INCORRECT LABEL ON DISTRIBUTION SERIES 2 ALARM SENSOR INPUT CONTACTS

DATE OF ISSUE: July 21, 2014

Figure 2 - Correct label

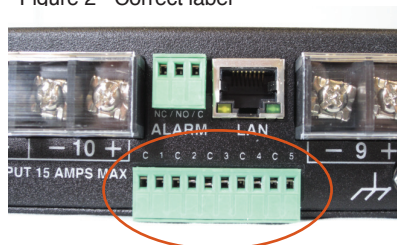
The ALARM SENSOR INPUTS – shown on Figure 1 – are incorrectly labeled. These inputs are used to monitor external dry contact sensors used to provide alarm notifications for third-party devices such as door, smoke, heat and water sensors.

This incorrect labeling may cause these alarm notifications to function incorrectly, but only in situations where a user ties all input commons (“C”) together.

The correct labeling is shown in Figure 2.

ICT will provide, at no cost, replacement labels that can be affixed over the existing label. To obtain, call 604-856-6303 or email sales@ictcorporate.com.
